POUND PLACE
ROUNDSTONE ROAD
ANGMERING

PROPOSED DRAINAGE LAYOUT
64 BED
SHEET 2

DRAWING NUMBER: PP-ISS-XX-XX-DR-C-3012 REVISION: C05

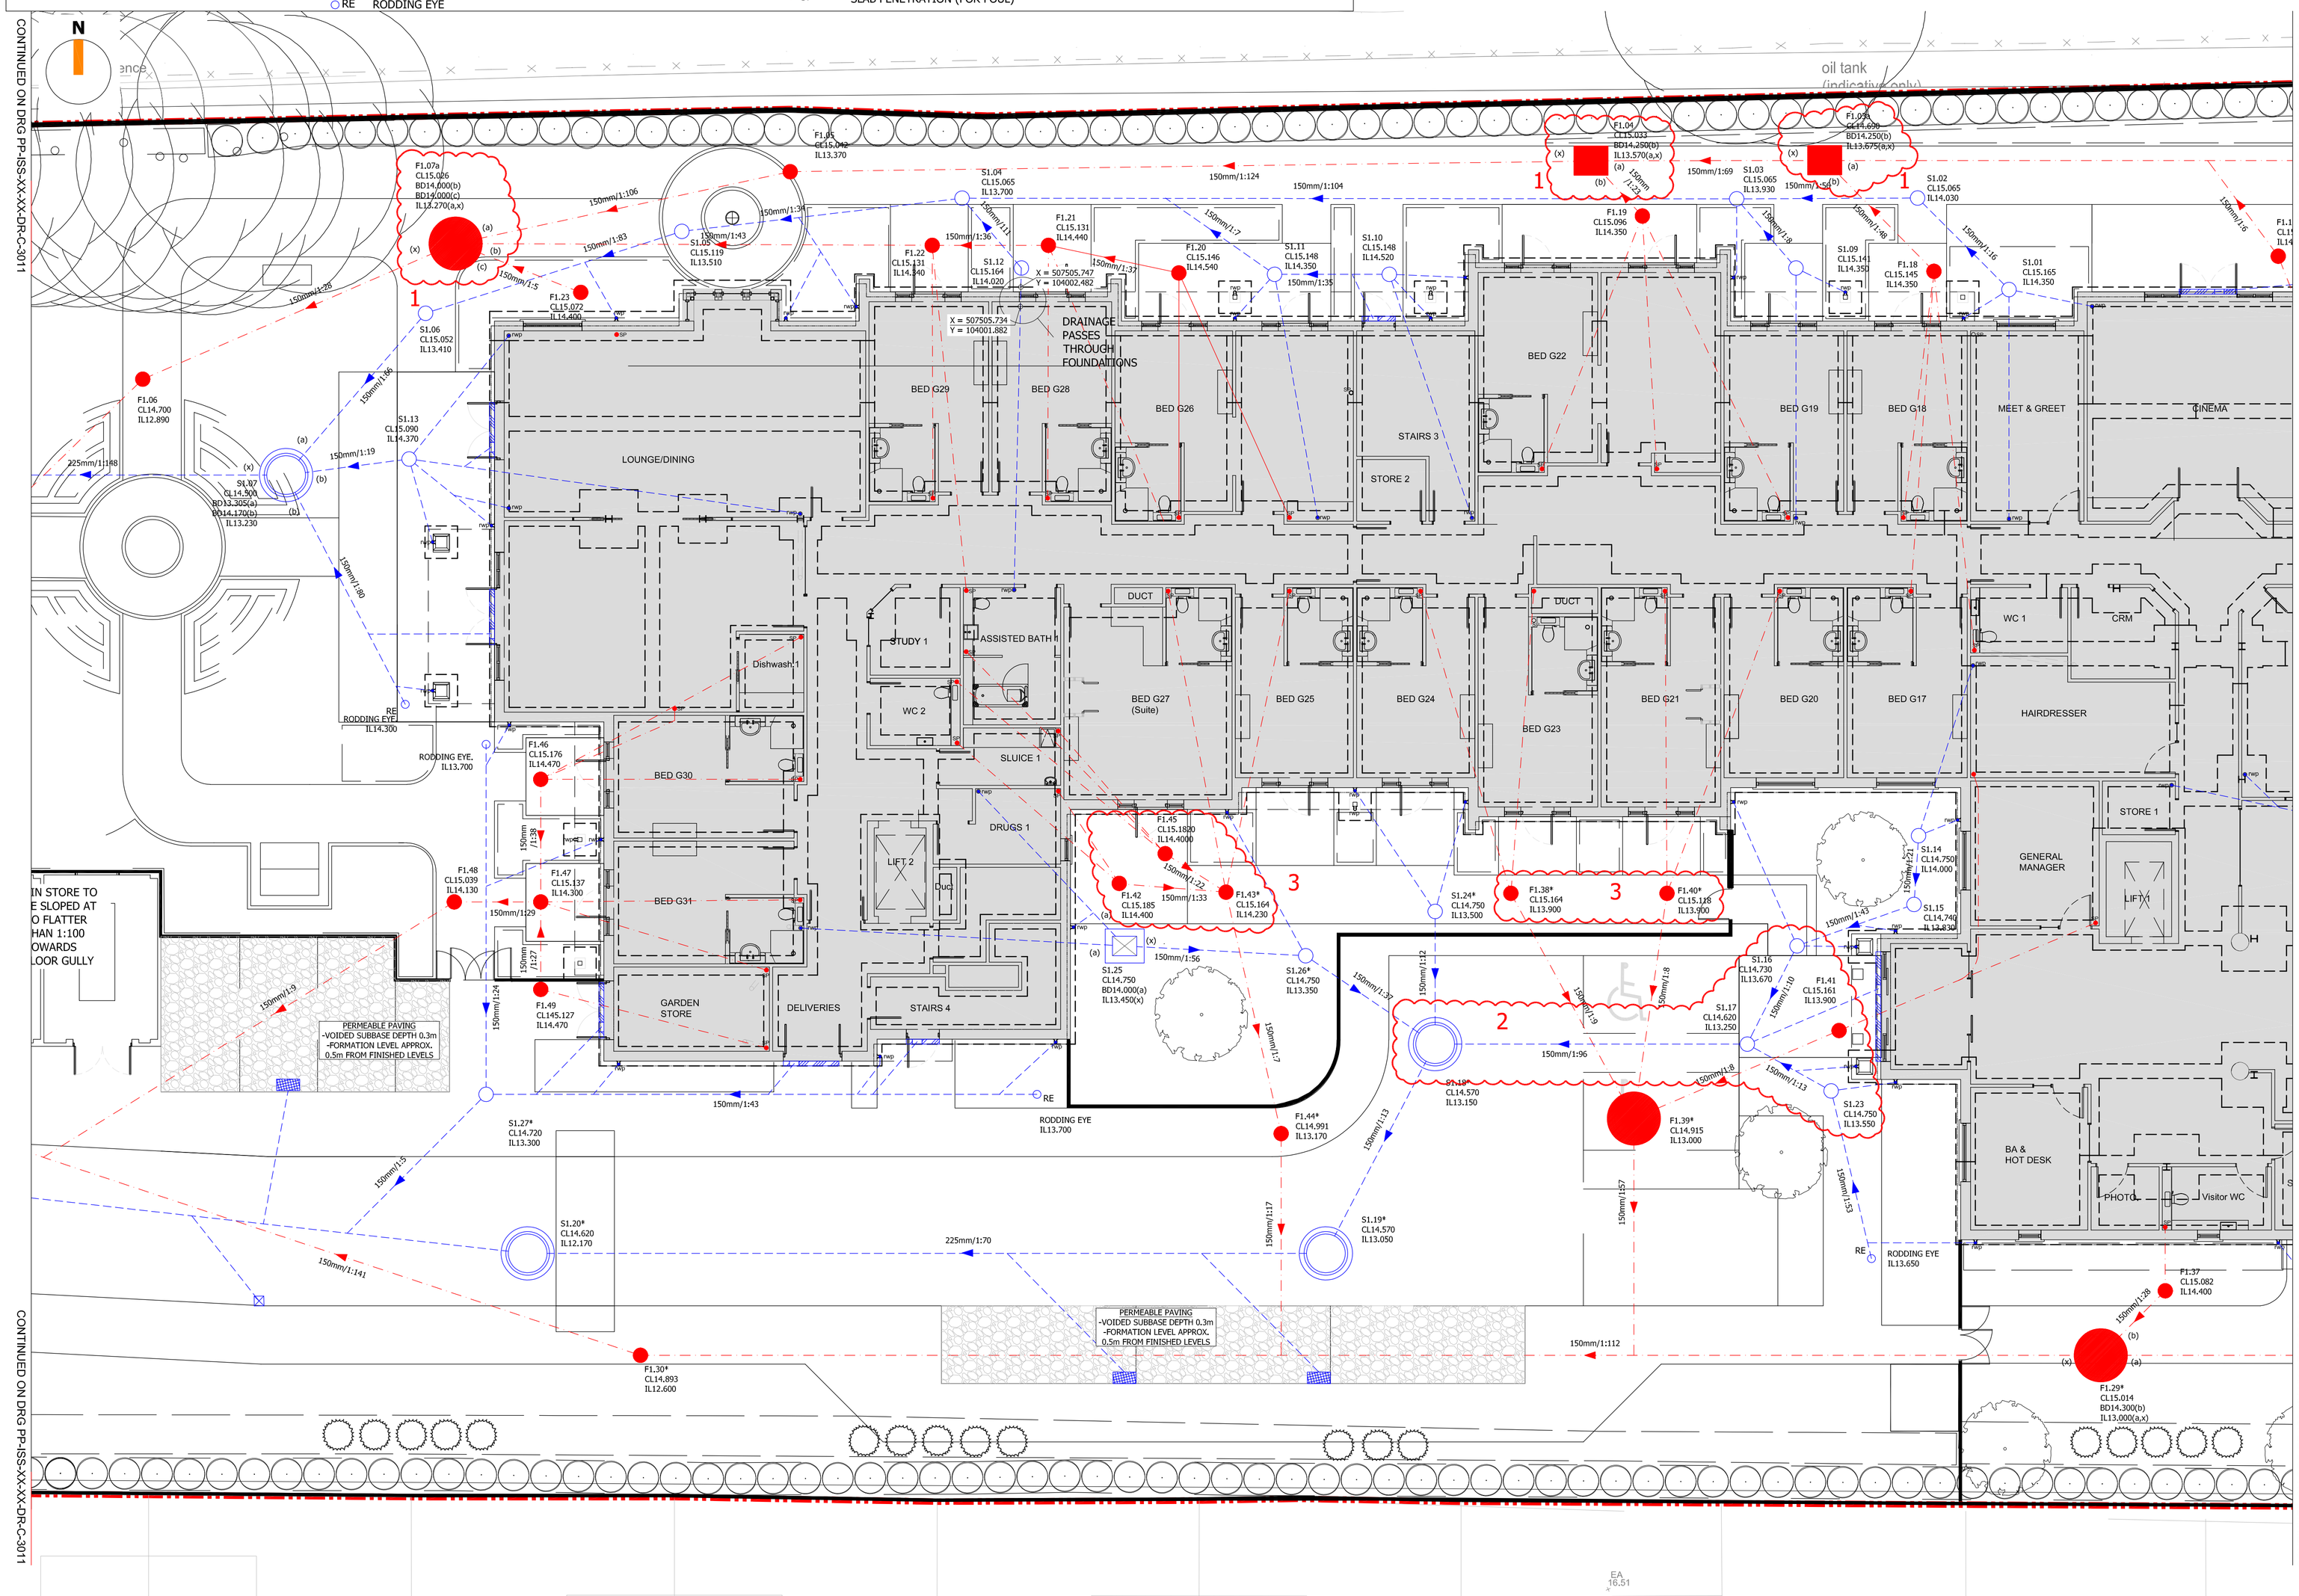
BUILDING FINISHED FLOOR LEVEL RAISED FROM 14.800 TO 15.200. DRAINAGE AMENDED TO SUIT. ALL COVER LEVELS AMENDED TO SUIT REVISED GROUND LEVEL DESIGN.

1. BACK DROPS MANHOLES ADDED TO ACCOUNT FOR LEVEL CHANGES.
2. SURFACE WATER NETWORK RATIONALISED TO REDUCE LENGTH OF DRAIN RUNS.
3. FOUL WATER NETWORK AMENDED TO AVOID CHAMBERS AT ENTRANCES WHERE POSSIBLE.
